Subject: Material for today's Light-duty GHG NPRM discussion.

Summary points from EPA review of CAFE model (NPRM version) – Effect of EPA code revisions

Meeting with Office of Management and Budget/OIRA

Figure 6 Change in VMT due Augural standards, with 0 percent rebound (relative to Proposed standards)

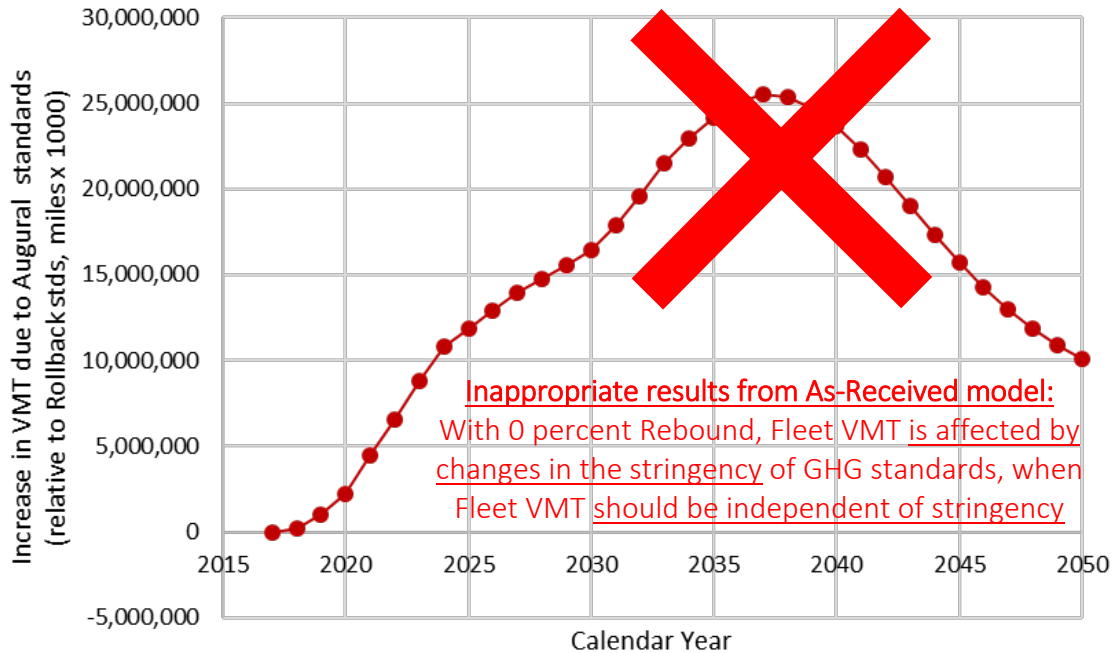
In addition to the problems described above with the As-Received model's implementation of the rebound effect, an additional inconsistency between VMT estimates generated by the model and the specified rebound value became evident when we looked at the VMT results for alternatives with different stringencies, holding rebound at 0 percent.¹⁰ With no rebound, we would not expect to see any change in total VMT, since by definition rebound is measured as the change in VMT for a given change in fuel cost per mile. However, even with 0 percent rebound, the As-Received model does produce total VMT values that are influenced by stringency level. See Figure 6, below. We believe that this zero-rebound VMT growth is an artifact of the disconnect between the sales model, scrappage model and mileage accumulation schedules described with Issue #1. And while this problem is not directly related to the model's calculation of the rebound effect, it points to the importance of carefully considering how the various elements are integrated when making changes or additions to a model.

In total, the As-Received model 1) inappropriately incorporates a vehicle age-related effect due to rebound, 2) exhibits directionally incorrect VMT changes in response to fuel economy improvements, and 3) produces a VMT response to changes in stringency even when the rebound value is set to 0. We conclude that the model’s implementation of the rebound effect is inappropriate, and that the model code produces VMT values that are inconsistent with the 20 percent rebound value that is specified in the input files. As with the problems described for the Scrappage Model in Issue #1, resolving the problems with the CAFE model’s implementation of the rebound effect is critically important. An inappropriate accounting of the rebound effect will produce unreliable VMT estimates, which in turn will produce unreliable estimates of net fuel savings, emissions costs, fatalities, etc., making it impossible to accurately evaluate and compare the various policy alternatives.

Figure 7 Effect of CPMref assumptions on CPMrate with 20 percent rebound (hypothetical example shown for MY2025 vehicle with 10 percent fuel economy improvement from MY2016 vehicle)

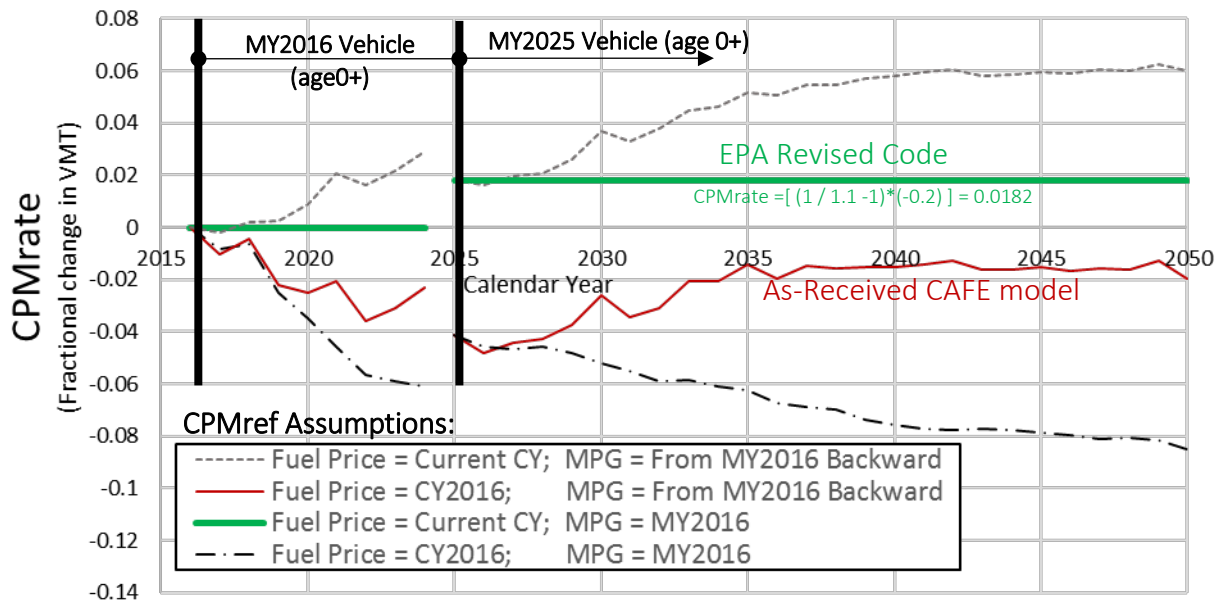
A hypothetical example will help to illustrate the importance of making appropriate assumptions when selecting CPMref. Building off the example in Figure 5 with MY2025 improvements to an average MY2016 car with fuel economy of 36.9mpg, Figure 7 shows how the CPMrate (and therefore the VMT) can change dramatically based on assumptions for CPMref. The inappropriate referencing of progressively older fleet average fuel economy values (red and gray curves), causes the CPMrate to be higher than when constant MY2016 reference fuel economy values are used (black and green curves.) The inappropriate referencing of CY2016 fuel prices (red and black curves) causes the CPMrate to be lower than when the current CY fuel prices are used (gray and green curves.) While these two problematic assumptions for CPMref tend to work in opposite directions, the general tendency of the As-Received model to produce a negative CPMrate in the example in Figure 7, despite the improvement in fuel economy, seems to indicate the assumption of maintaining CY2016 fuel prices is dominant.

We believe that the most defensible implementation of the rebound effect is one that maintains the same CPMrate over every calendar year in the course of a vehicle lifespan. In the example shown by the green line in Figure 7, the CPMrate for the MY2025 vehicle then becomes simply a function of the ratio of the reference fuel economy to the new fuel economy and the 20 percent rebound effect value, or $[(1 / 1.1) - 1] * (-0.2) = 0.0182$. To achieve this, we revised the CAFE model code so that:

Figure 8 Cost and Effectiveness of MY2030 vehicles relative to a 'null' tech package (PEV's are off chart area, but included in fleet average)

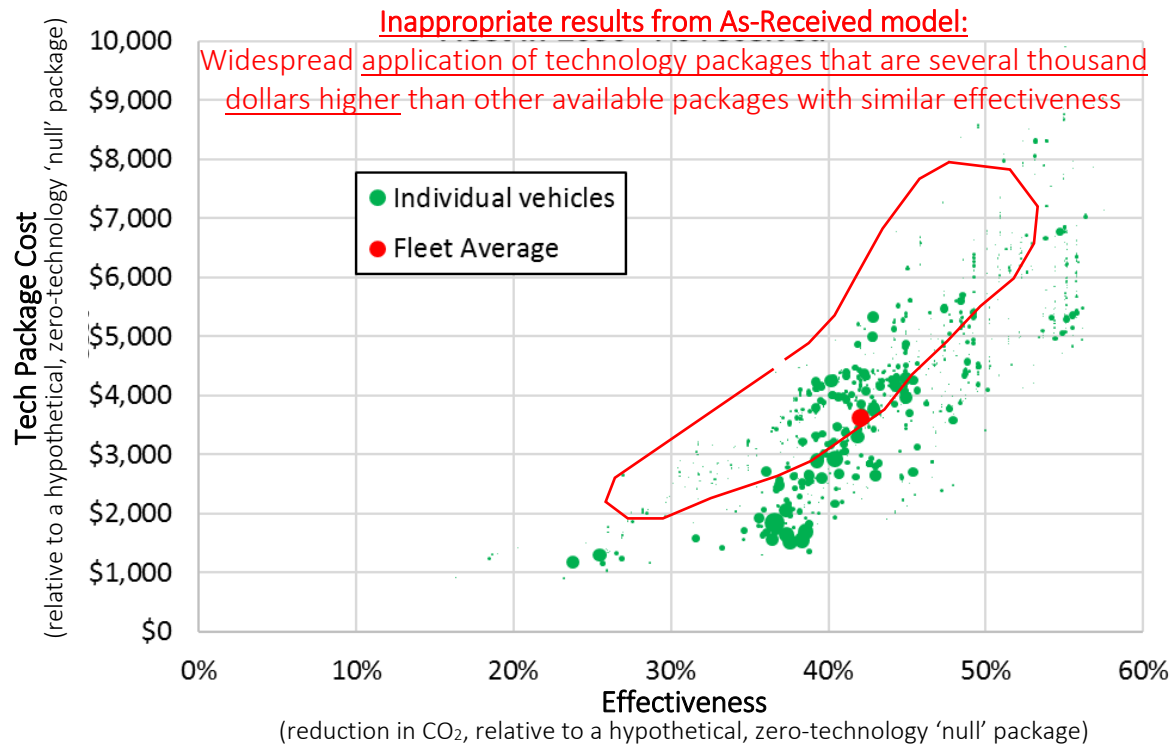
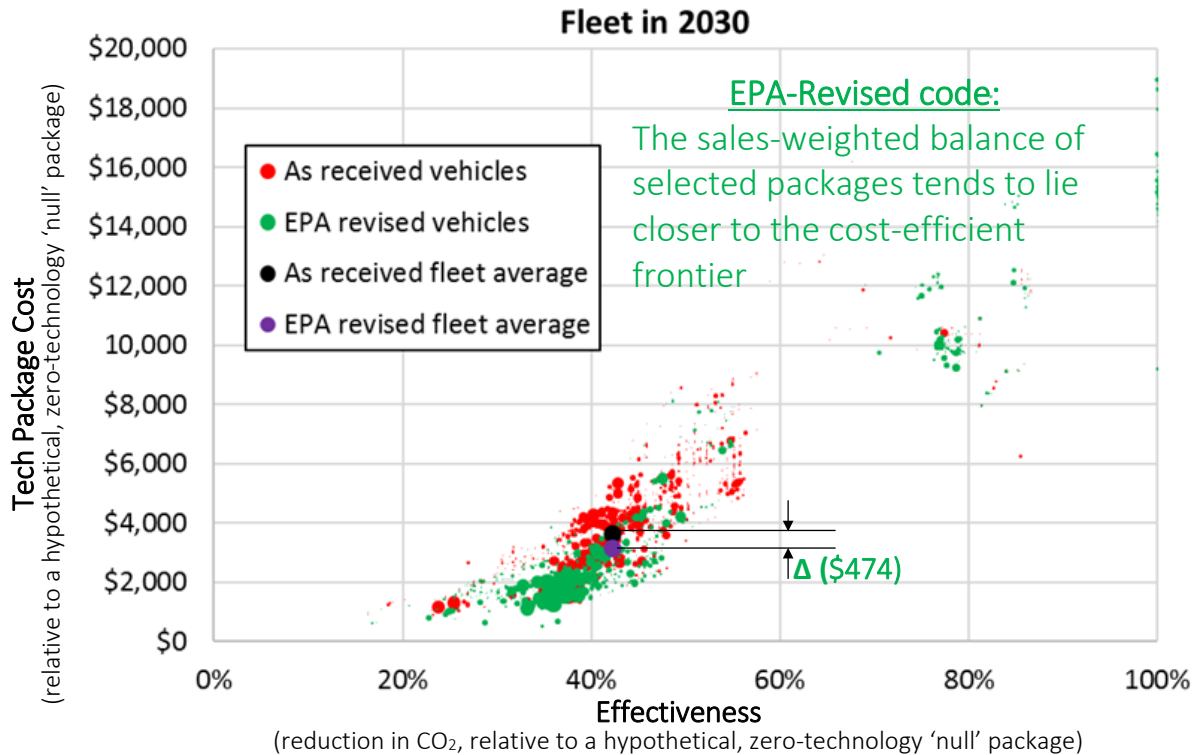
Figure 8 shows the total technology cost and effectiveness for all technology packages applied by the As-Received CAFE model to the MY2030 fleet, relative to a ‘null’ package with only basic technologies.¹² While we would not expect manufacturers to consistently apply technology packages that lie exactly on the cost-efficient ‘frontier’, the frequency with which the As-Received CAFE model applies packages that are several thousand dollars more expensive than other available packages is striking.

To resolve the issue of the cost-ineffective technology application decisions, EPA revised two elements of the CAFE model code. First, we revised “efficiency” calculation used for package ranking. Because we don’t believe that the value of a CO₂ credit to any manufacturer can be reasonably determined in advance¹⁴, we have removed the monetary valuation of CO₂ credits from the numerator of Equation 3, and instead include the change in quantity of compliance credits (in grams CO₂) as a normalizing factor in the denominator of the efficiency calculation. The modified calculation, shown as Equation 6, can be interpreted as the cost-efficiency of a technology application in terms of the net cost per gram CO₂ credits earned. We think that this decision rule would reasonably represent a manufacturer that is applying technologies in a cost-minimizing manner, subject to all the original constraints on technology availability and redesign cycles specified in the As-Received CAFE model input files. As with the As-Received CAFE model logic, our revised code prioritizes technology packages with more negative efficiency values.

Figure 9 CO₂ Credit Value, by Model Year, as defined in As-Received CAFE model inputs

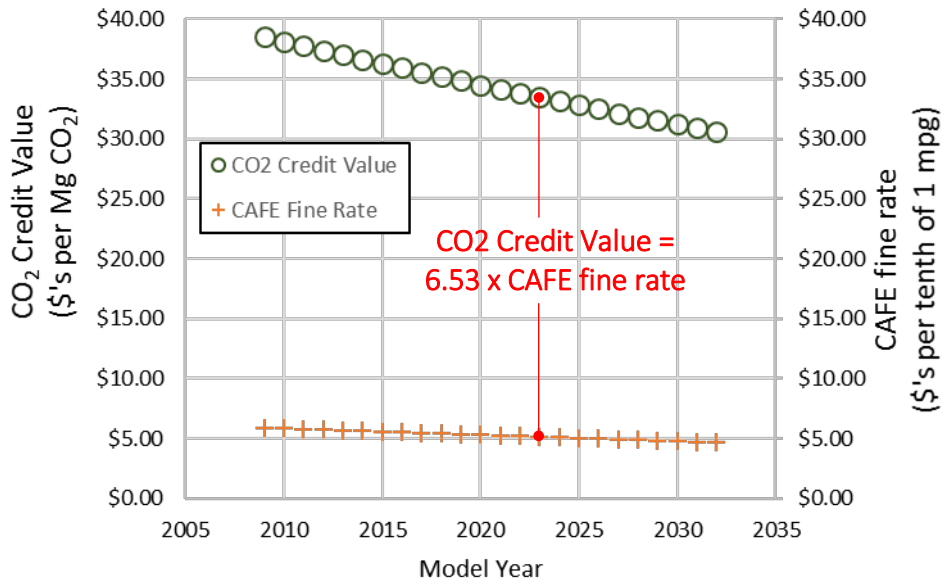
Figure 9 shows the CO₂ Credit Values by Model Year, which are defined in CAFE model input files using a simple scaling of the CAFE fine rates by a constant factor of 6.53. While the application of a uniform credit value is problematic given all the potential variations among manufacturers, it is probably even more problematic that the CO₂ value is assumed to be decreasing over time. Given that the GHG program does not allow manufacturers to pay fines as a compliance strategy, we assume that NHTSA's intent was for the CO₂ credit value to represent a market value for trading credits between manufacturers. Regardless of the intent, as the adoption of the lower-cost technologies leaves only the more expensive alternatives available to meet future year stringency increases, it is implausible that the value of CO₂ credits to a manufacturer will decrease in this way over time.

Figure 10 Effect of truncating CO₂ credit value in CAFE model's 'efficiency' calculation for tech package selection
 Assuming \$3/gal fuel price, \$35/MgCO₂ credit value, and 30k miles driving in first 2.5 years (for consumer payback)

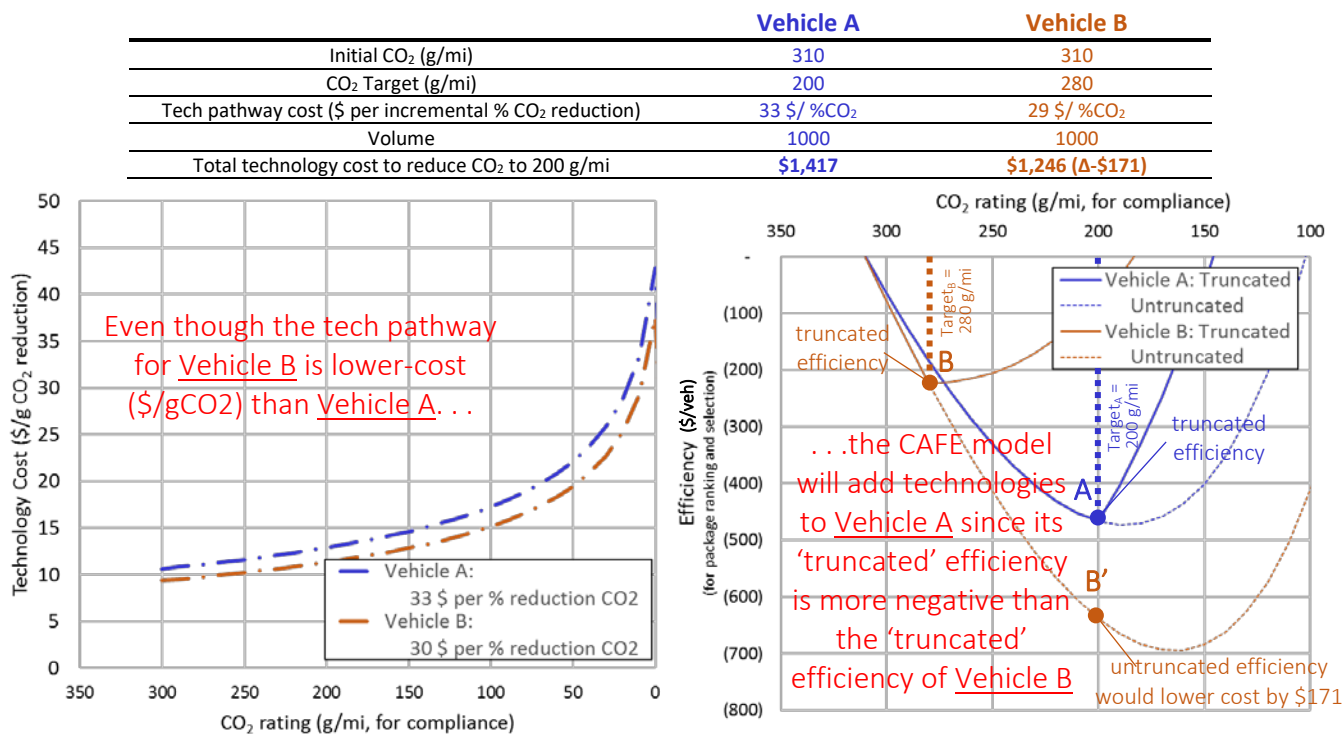
as shown in Figure 10, since the credit value for reducing Vehicle B below its 280 g/mi target is truncated and not included in the efficiency calculation. The CAFE model will choose to apply technology to Vehicle A to reduce CO₂ to 200 g/mi, even though that technology pathway is less cost effective than one where technology is applied to Vehicle B (point B' in Figure 10) – with a technology cost of \$1,417 for Vehicle A compared to \$1,246 for Vehicle B for the same CO₂ reduction.

Figure 18 EPA Revised Code Effects, Compare to As-Received CAFE model results in Figure 11 “MY2030 Required and Achieved CO₂ levels for Each manufacturers regulatory car and truck fleets”

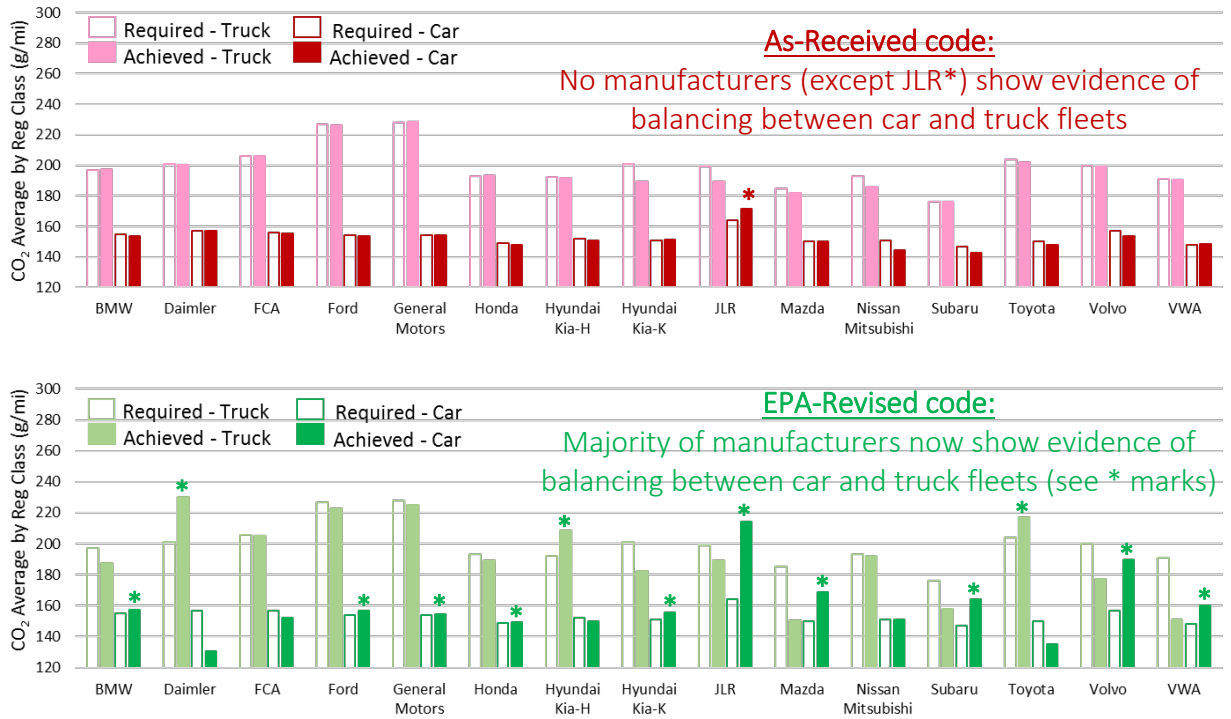
The third factor that contributes to the CAFE model's application of cost-inefficient packages is the separate treatment of regulatory classes when determining compliance status. Figure 11 below shows that with only one exception,¹³ the achieved CO₂ levels for the regulatory car and truck fleets for all manufacturers in MY2030 is below the required CO₂ level. This result is striking, not only in the consistency of overcompliance, but also in the apparent lack of balancing within a manufacturer between car and truck regulatory fleets. A more realistic modelling representation would tend to show some overcompliance in one regulatory fleet, offset by undercompliance in the other fleet as the manufacturer seeks to reduce compliance costs by applying technology to reduce emissions where it is most cost-effective.

The second change in the EPA-Revised code involves the lack of credit transfers between regulatory classes. As shown in Equation 7, we now set each manufacturer’s ‘in compliance’ flag based on the

Figure 2 Incremental Effectiveness of TURBO2 to CEGR1 (MedCarPerf class)

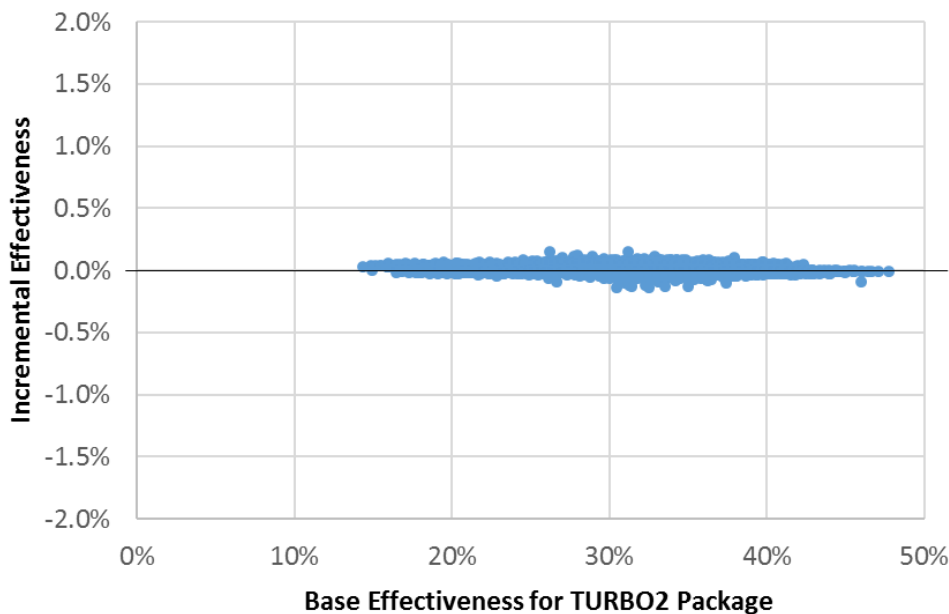
Observation 3: *The addition of cooled exhaust gas recirculation (CEGRI) onto turbocharged engines (TURBO2) provides no relative benefit, despite the additional cost of the technology. Given this input assumption, the CAFE model outputs, as expected, do not show application of CEGRI.*

A cooled EGR package when added to the advanced turbocharged engine (TURBO2) has a cost of \$334 in 2030. Cooled EGR is a technology that has been used in the market, and has a significant effect on CO₂ reduction. However, as illustrated in Figure 2, the incremental effectiveness is at or near zero for EPA findings on initial review of NHTSA Jan-22, 2018 CAFE model runs (final version for 2/12/2018 NHTSA briefing)

Figure 3 Incremental Effectiveness of the best six-speed (AT6L2) v. the best eight-speed (AT8L3) (Small SUV)

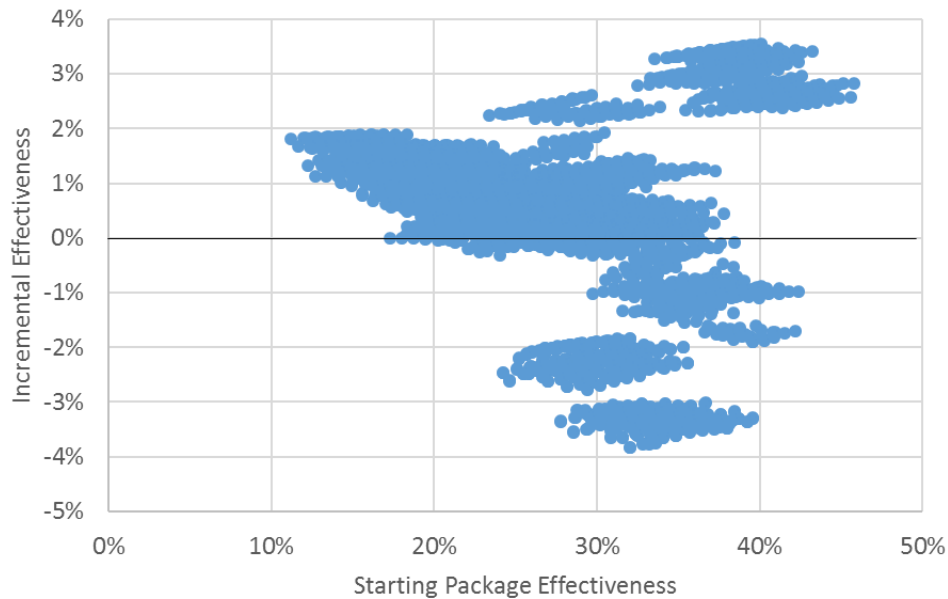
The modeled automatic transmissions include one “improved” level of a six-speed automatic (AT6L2) and two improved levels of eight-speed automatics (AT8L2 and AT8L3). The cost of the AT6L2 package (additional to an AT6) is \$362 in 2030. The cost of the AT8L3 package (additional to an AT8) in 2030 is nearly the same (\$358). Incremental to the AT6, the best eight-speed package is \$485 (i.e., \$123 more than the AT6L2). However, on average, the technology inputs provided show that the AT8L3 is only 1% more effective than the AT6L2, and in some cases is worse (as shown by the Small SUV plot).

Figure 5 Incremental Effectiveness of 48V Mild Hybrid with belt-integrated starter-generator (BISG) to crank-integrated starter-generator (CISG) (Small Car class)

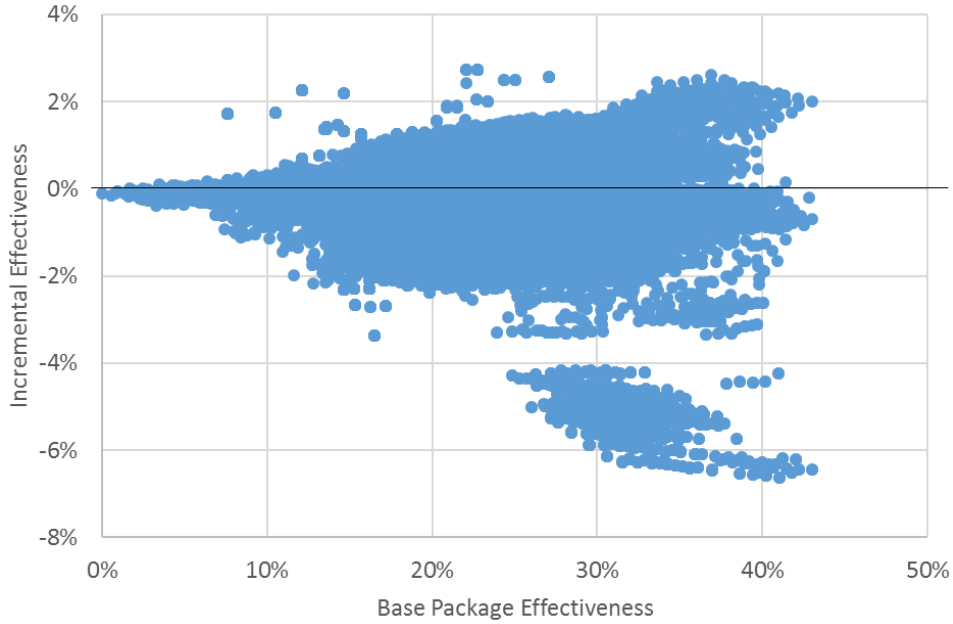
However, on average, the CISG is slightly less effective than the BISG, although with a wide spread of effectiveness. The small car example shown in Figure 5 is typical, with the incremental effectiveness of most packages between about +1% and -1%.

Figure 9 Fixed Effect Values used in the Safety Analysis

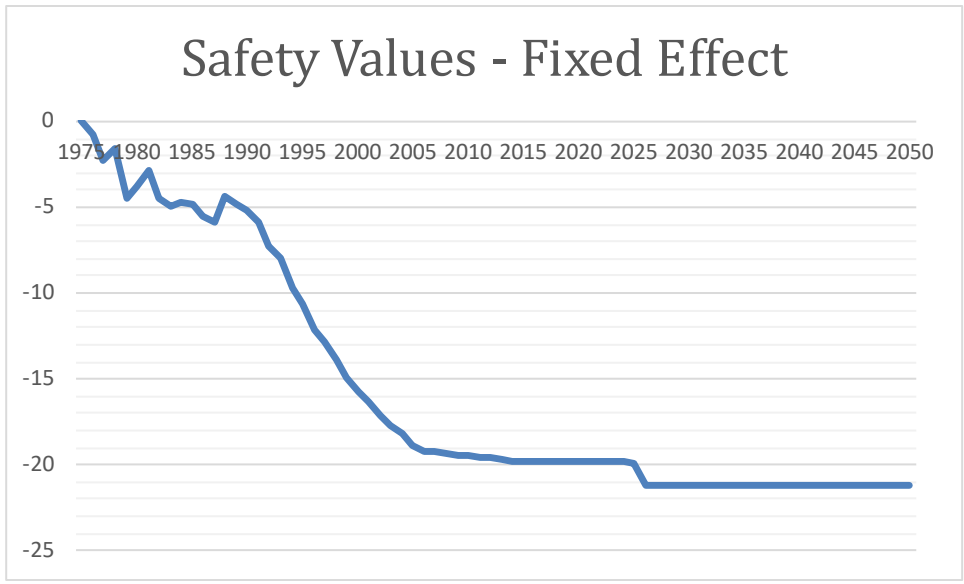
Question/Information Request 17. How are the “fixed effects”, as presented in the safety values sheet of the parameters input file estimated? Why are values flat from 2014 through 2021? Why do they decrease beyond 2021? Why the large step change reduction in 2026 with a flattening beyond 2026?

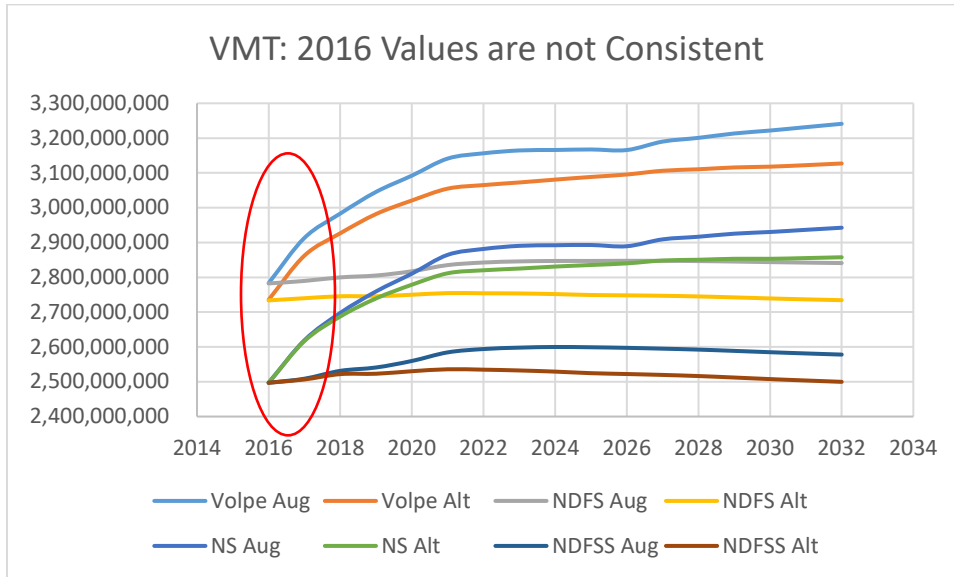
- The smaller overall fleet with the Alternative standards relative to the Augural standards implies that more people give up used vehicles than are buying new vehicles – that is, relative to the Augural standards, lower new vehicle prices shrink the overall fleet. Why does the overall fleet shrink when switching to the Alternative standards from the Augural standards?
